ADDENDUM

ADDENDUM NO.: 03
PROJECT NAME: Kenwood Academy High School Link and Mechanical Project
PROJECT NO.: 05326
CONTRACT NO.: C1602
DATE OF ISSUE: October 25, 2022

NOTICE OF CHANGES, MODIFICATIONS, OR CLARIFICATIONS TO CONTRACT DOCUMENTS

Title:
CIVIL SITE GEOMETRIC PLAN

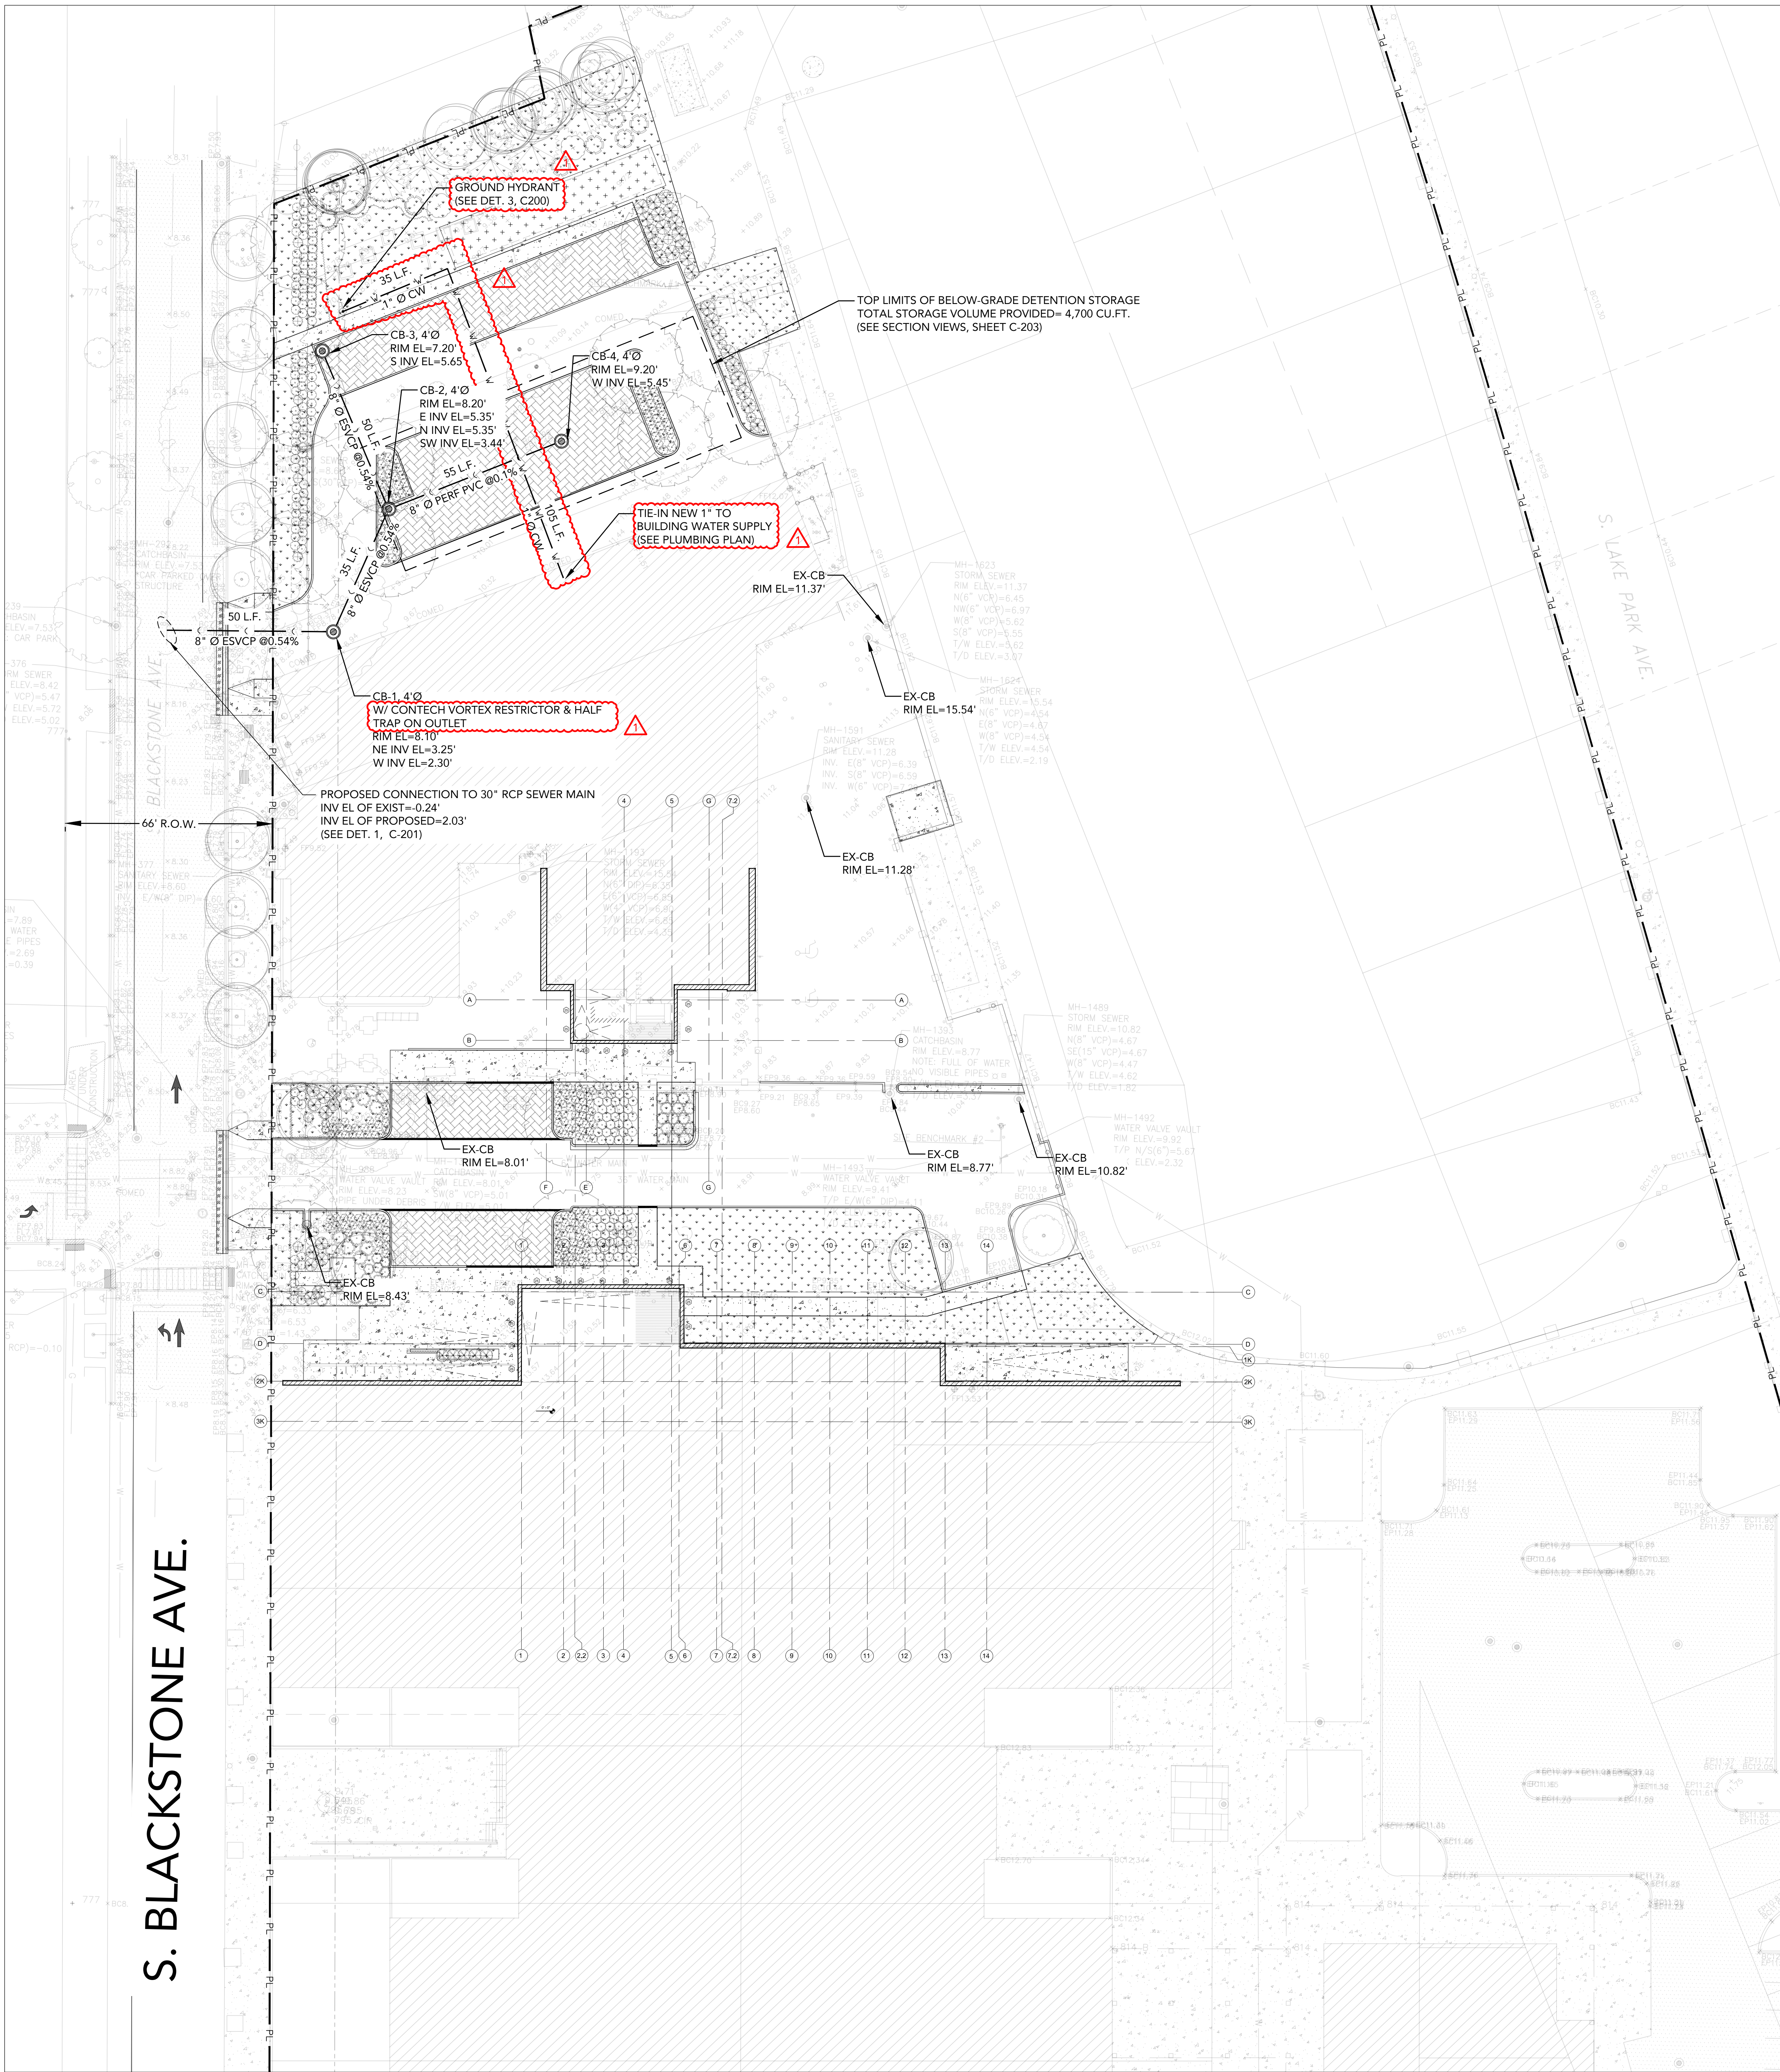
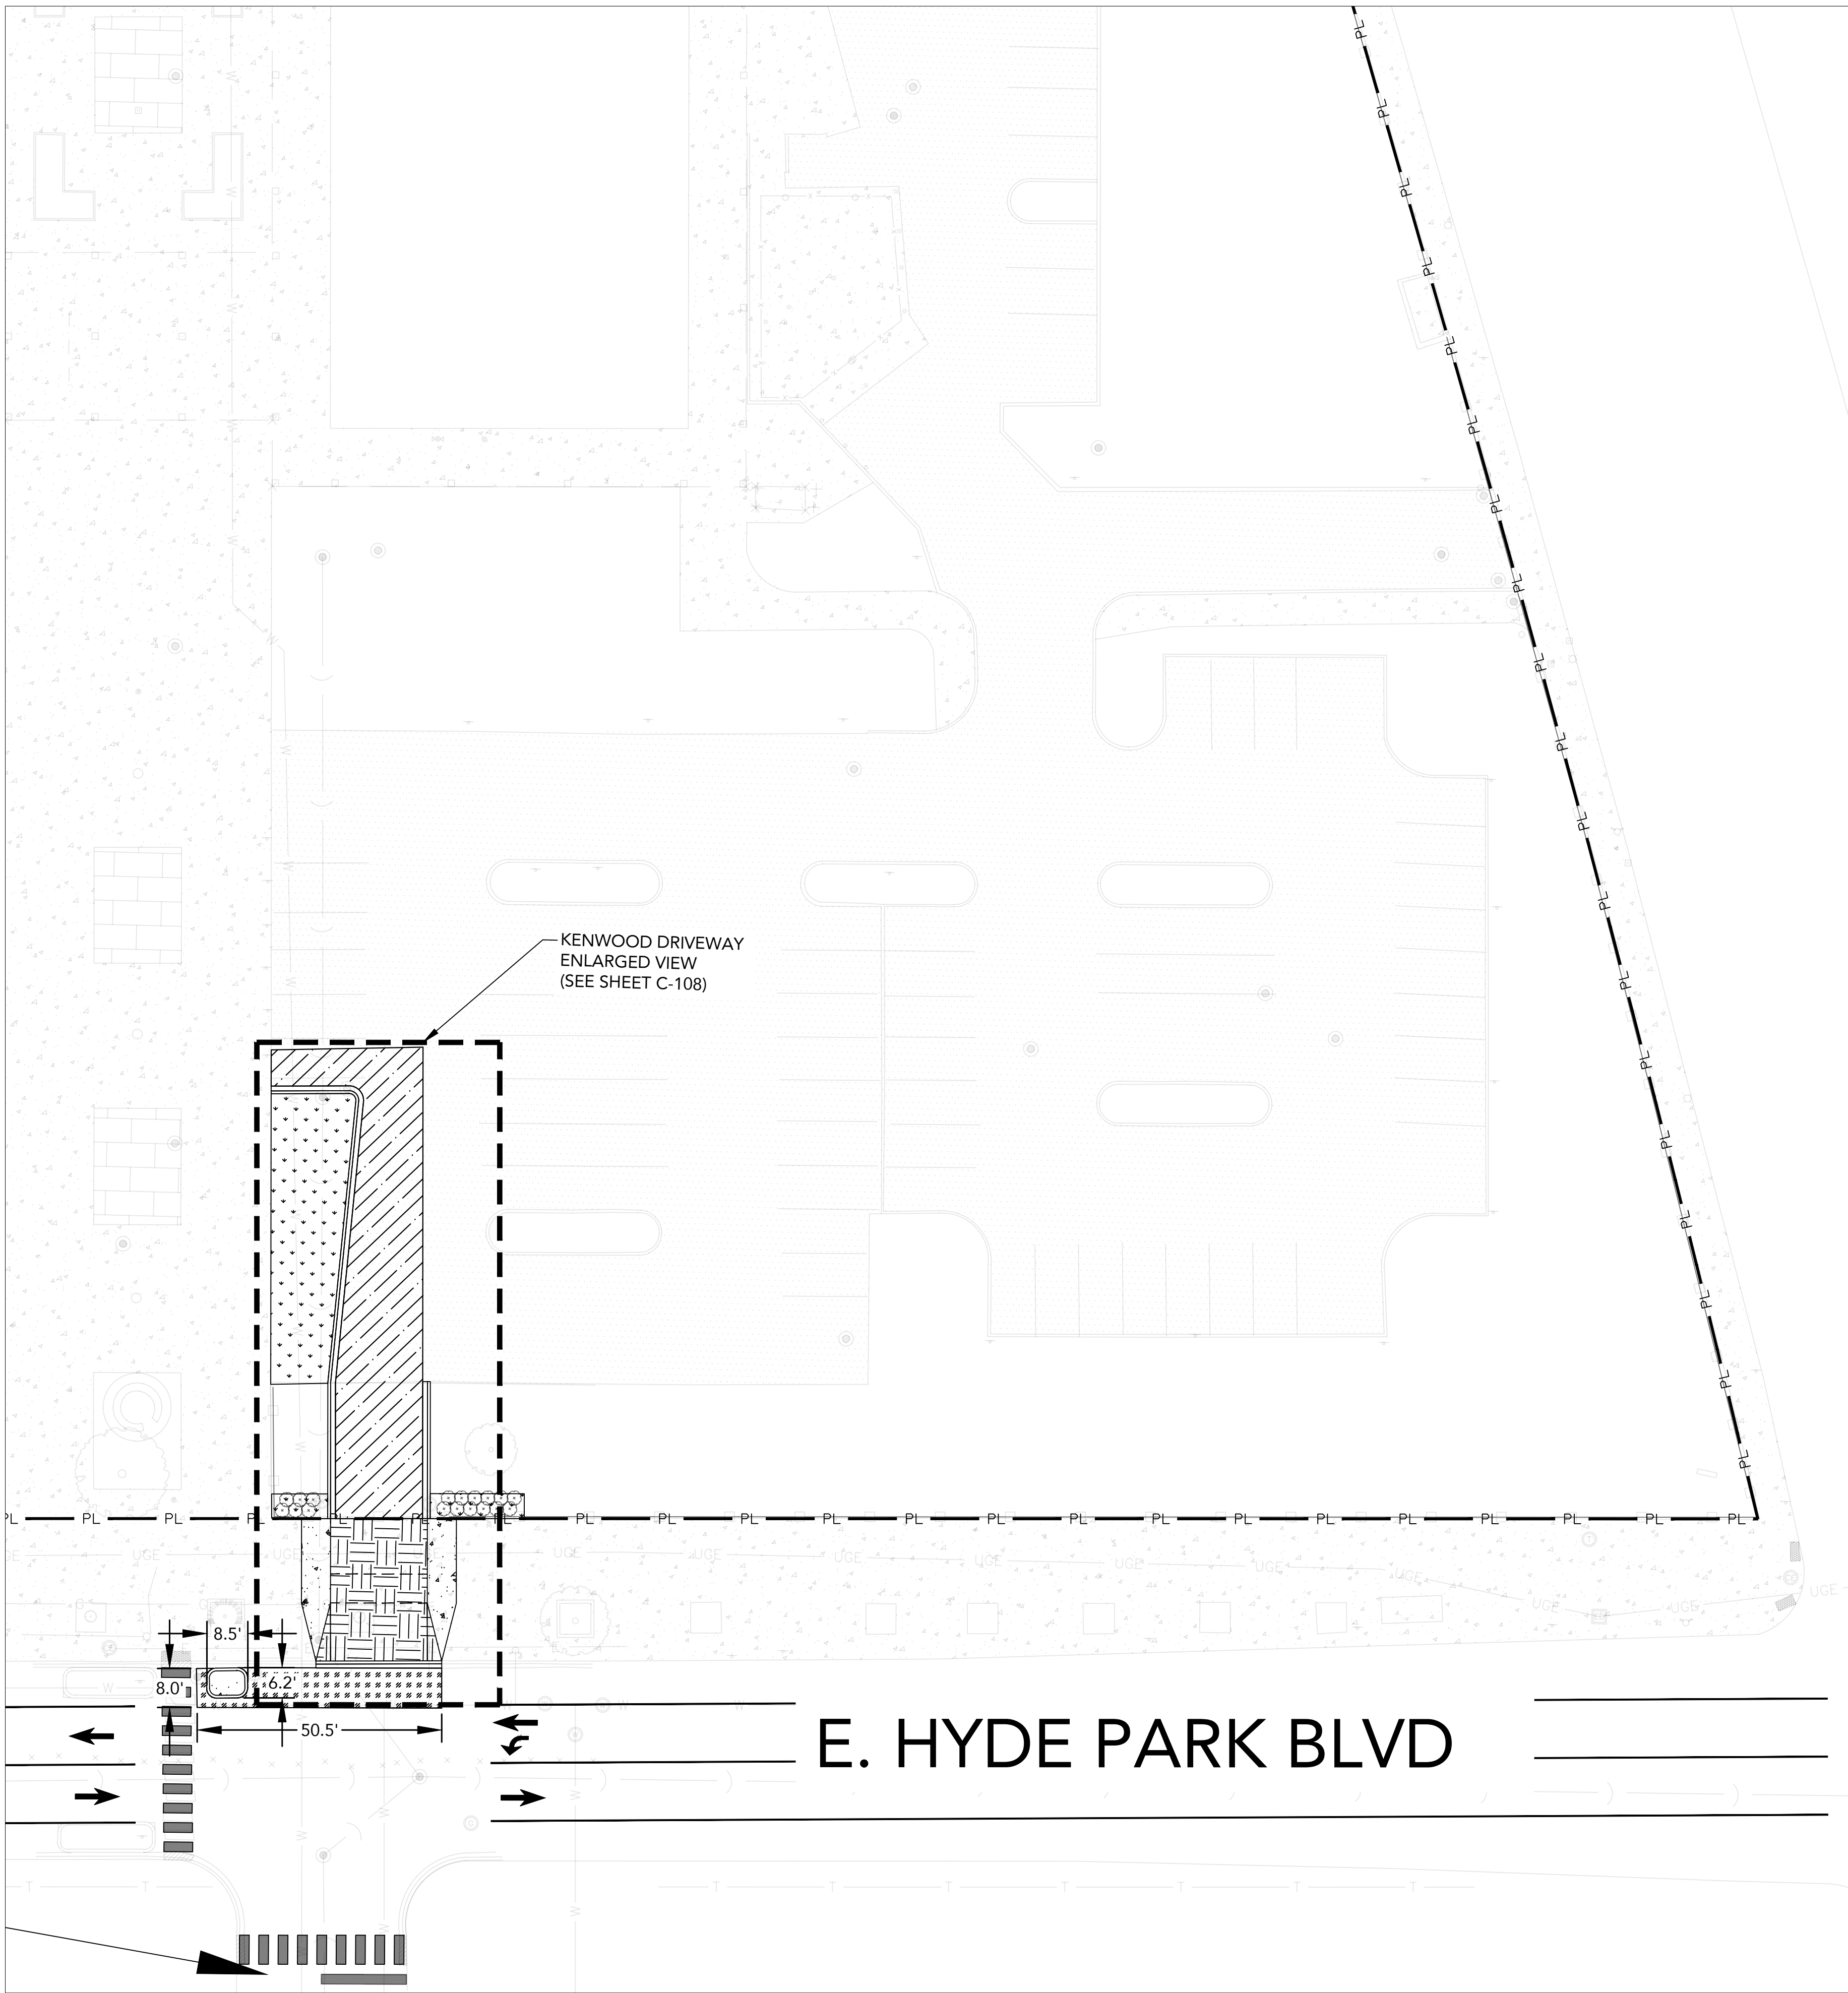
Question: C 108 shows an enlarged view of the Kenwood Driveway. Please confirm if the asphalt pavement shown is also to be included in the bid option for concrete pavement in lieu of asphalt?

Question: Please provide a clear legend for the Civil site plans and demo. Hatch marks and legends do not completely match the drawings and some drawings show hatch marks not seen in the legend.

Response: Bidders are advised that the bid option in the Geometric Pavement Legend on Sheet C-103 is deleted. A revised Sheet C-103 is attached.

Response: An updated Geometric Pavement Legend is included on Revised Sheet C-103, which is included in this Addendum No. 3.

Title: CIVIL UTILITY PLAN

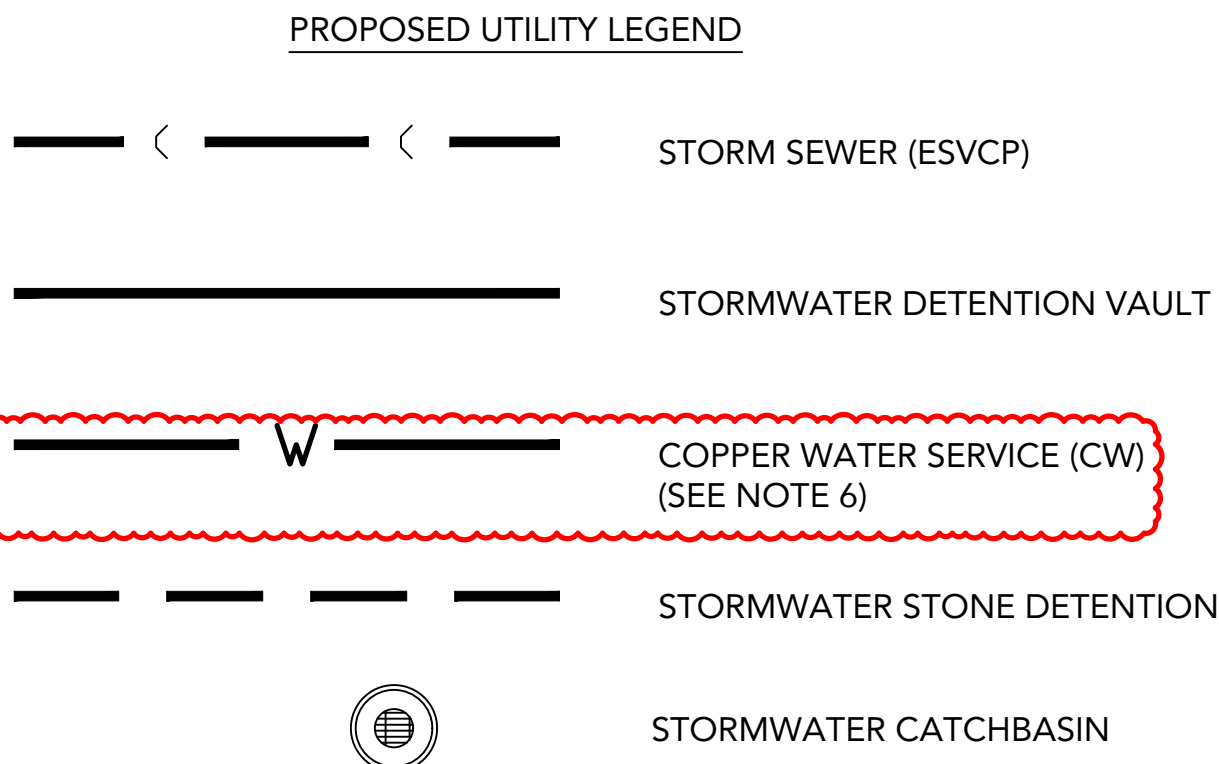
Question: Per sheet C-105 Note 2 “stormwater detention vault beneath proposed lot” – please clarify the work to be done per that note with a detail. Is there already a vault there? Are we excavating for a proposed vault? Is there any work that is to be done regarding the stormwater detention vault? Etc.?

Question: There is a detail for a ground hydrant to be furnished, however there is no location for the hydrant to be installed. Please clarify where this hydrant is to go and how many there are to be installed.

Response: Bidders are advised there is no Stormwater Detention Vault for this project. A revised Sheet C-105 with Note 2 deleted is included in this Addendum No. 3.

Response: The Ground Hydrant is located at the North Parking Lot. A revised Sheet C-105 including hydrant, water service line, and tie-in, is included in this Addendum No. 3.
